Legend Shift Problem Correction

ACURA ServiceNews

BSN 16053 (9308)

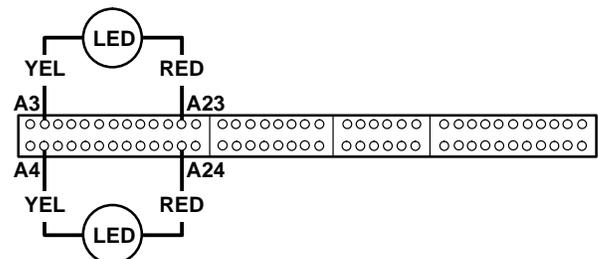
In the July '92 issue of S/N, we did an article on checking Vigor A/T shift solenoid signals while you drive ("Shift Problem: Trans or Control Unit?"). In the November '92 issue, we told you how to perform the same check on a '91-93 Legend. However, we reversed the terminal connections in the illustration of the Legend article, although the text was correct. (Do as we say, not as we illustrate?) So here it is again, with the correct illustration:

Connect LED A to terminals A23 (+RED) and A3 (-YEL), and LED B to A24 (+RED) and A4 (-YEL). Staple a photocopy of *this* Legend illustration to your July '92 issue.
